The Commission has issued the enclosed Amendments No. 4 to Facility Licenses No. DPR-32 and DPR-37 for the Surry Power Station, Units 1 and 2. The amendments include Change No. 19 to your Technical Specifications for each license and are in response to your request dated October 17, 1974, as supplemented November 20, 1974.

The amendments revise the provisions in the Technical Specifications relating to the replacement of 84 of 157 fuel assemblies in the reactor core, constituting refueling of the core for second cycle operation of Unit 1.

ATTACHMENT TO LICENSE AMENDMENT NO. 4  
CHANGE NO. 19 TO THE TECHNICAL SPECIFICATIONS  
FACILITY OPERATING LICENSE NO. DPR-32  
VIRGINIA ELECTRIC & POWER COMPANY  
SURRY POWER STATION UNIT NO. 1  
DOCKET NO. 50-280

SAFETY EVALUATION BY THE DIRECTORATE OF LICENSING  
SUPPORTING AMENDMENTS NO. 4 TO LICENSES NO. DPR-32 AND DPR-37

FIGURE 2.1-1A REACTOR CORE THERMAL & HYDRAULIC SAFETY LIMITS-  
THREE LOOP OPERATION, 100% FLOW-UNIT NO. 1

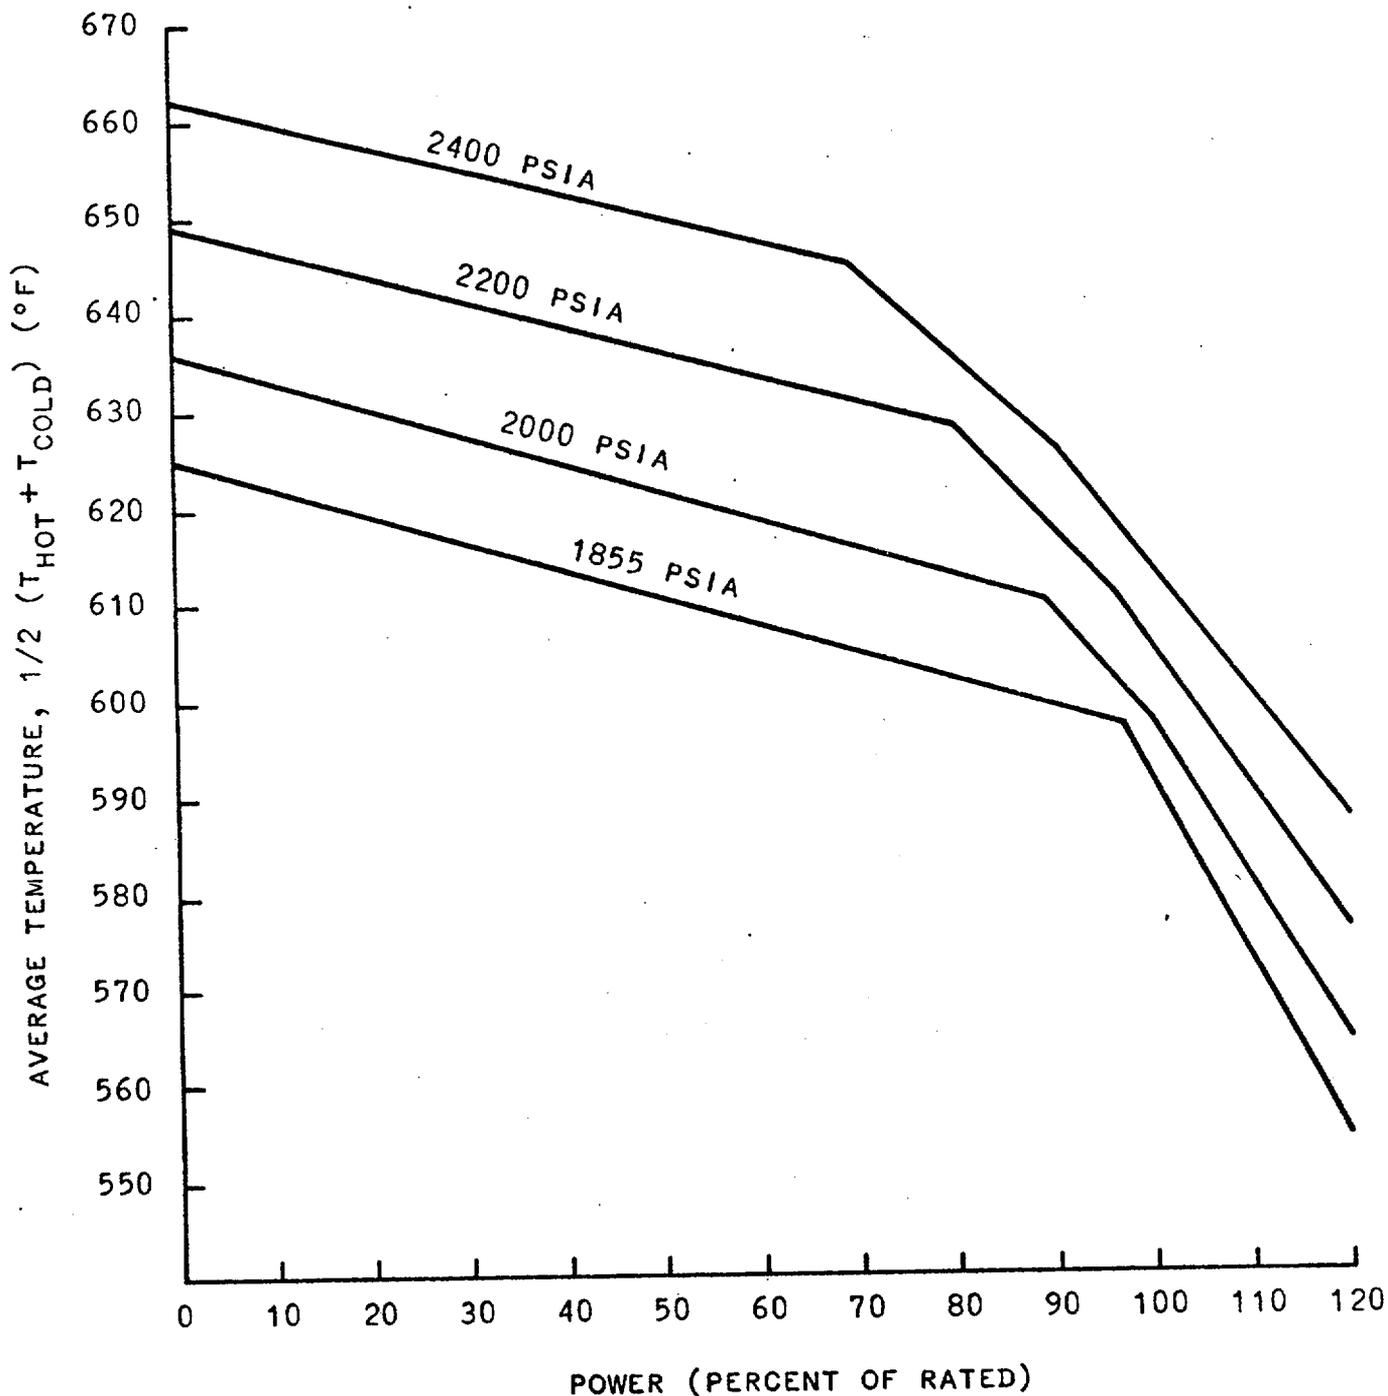
The curves of TS Figures 2.1-1A (Unit 1) and 2.1-1B (Unit 2) which show the allowable power level decreasing with increasing temperature at selected pressures for constant flow (three loop operation) represent limits equal to, or more conservative than, the loci of points of thermal power, coolant system average temperature, and coolant system pressure for which the DNB ratio is equal to 1.30 or the average enthalpy at the exit of the core is equal to the saturation value. The area where clad integrity is assured is below these lines. The temperature limits are considerably more conservative than would be required if they were based upon a minimum DNB ratio of 1.30 alone but are such that the plant conditions required to violate the limits are precluded by the self-actuated safety valves on the steam generators. The three loop operation safety limit curve has been revised to allow for heat flux peaking effects due to fuel densification.

TS Figures 2.1-1A through 2.1-3B are based on a  $F_{\Delta H}^N$  of 1.55, a 1.55 cosine axial flux shape and a DNB analysis as described in Section 4.3 of the report Fuel Densification Surry Power Station, Unit 1 dated December 6, 1972 (including the effects of fuel densification). They also include an allowance for an increase in the enthalpy rise hot channel factor based on the expression:

FIGURE 2.1-2A REACTOR CORE THERMAL AND HYDRAULIC SAFETY LIMITS, TWO LOOP OPERATION, LOOP STOP VALVES OPEN-UNIT NO. 1

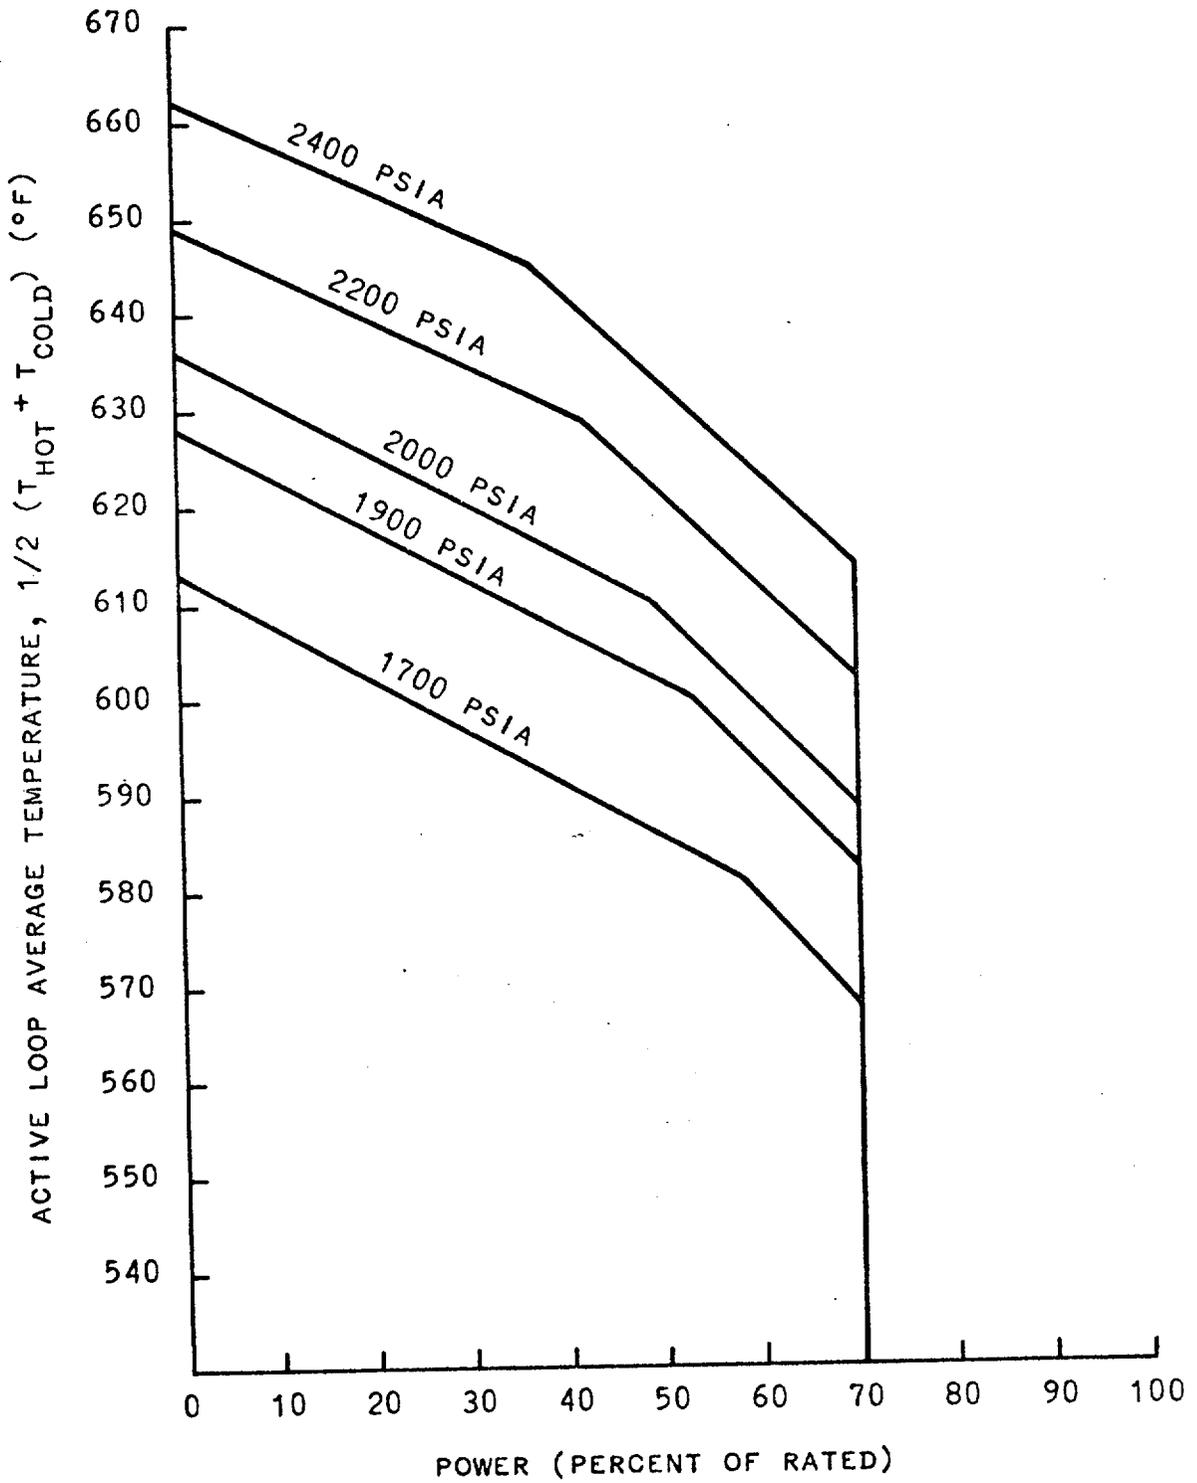
The curves of TS Figures 2.1-2A (Unit 1), 2.1-2B (Unit 2), 2.1-3A (Unit 1), and 2.1-3B (unit 2) which show the allowable power level decreasing with increasing temperature at selected pressures for constant flow (two loop operation), represent limits equal to, or more conservative, than the loci of

FIGURE 3.12-1A CONTROL BANK INSERTION LIMITS FOR 3-LOOP NORMAL OPERATION-UNIT 1

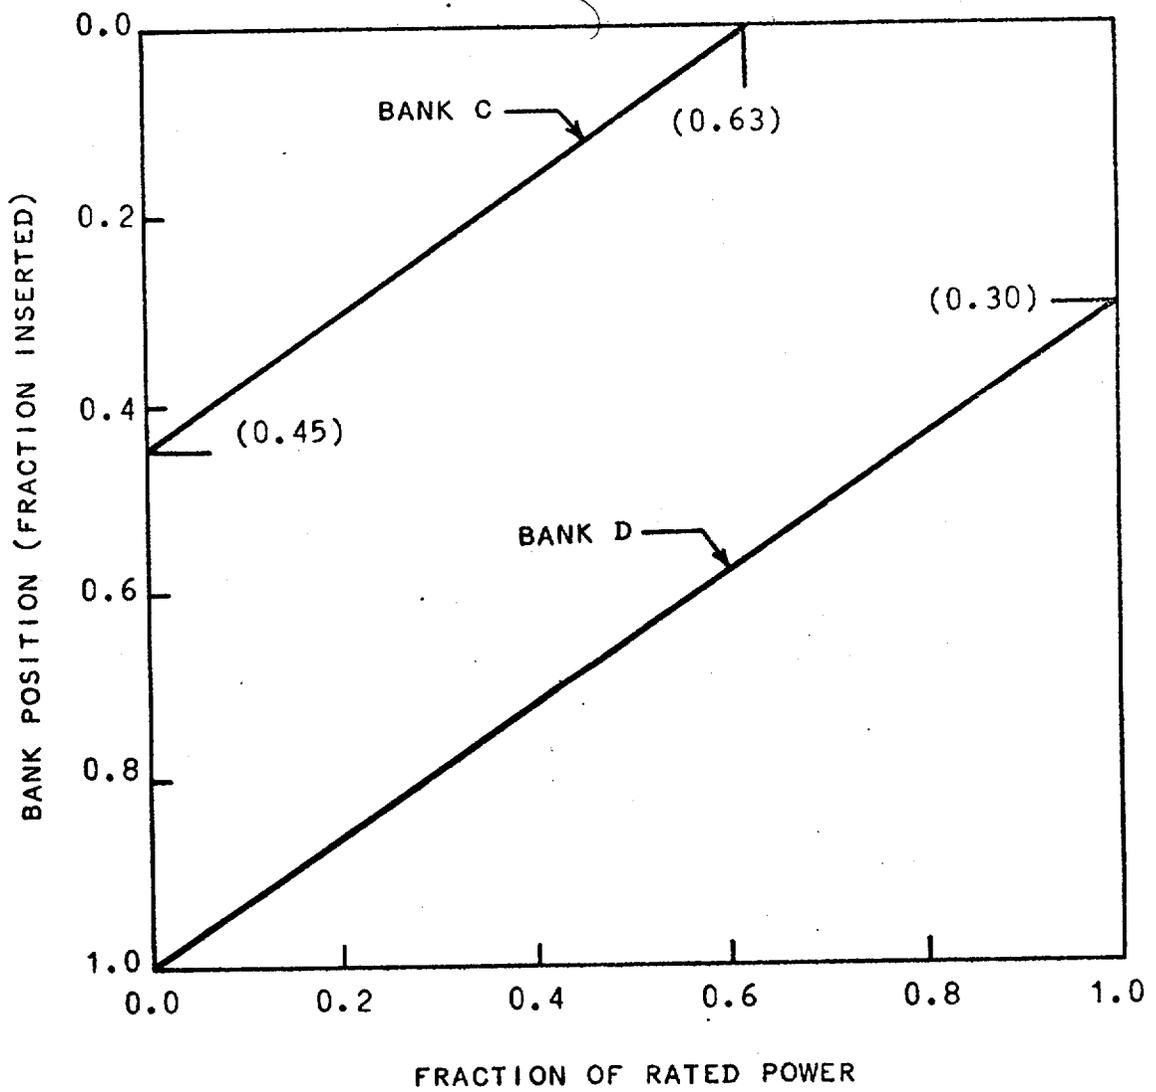
2. Whenever the reactor is critical, except for physics tests and control rod assembly exercises, the full length control rod banks shall be inserted no further than the appropriate limit determined by core burnup shown on TS Figures 3.12-1A, 3.12-1B, 3.12-2, or 3.12-3 for three-loop operation and TS Figures 3.12-4A, 3.12-4B, 3.12-5, or 3.12-6 for two-loop operation.

1. Control rods in a single bank move together with no individual rod insertion differing by more than 15 inches from the bank demand position.
2. Control rod banks are sequenced with overlapping banks as shown in Figures 3.12-1A, 3.12-1B, and 3.12-2.
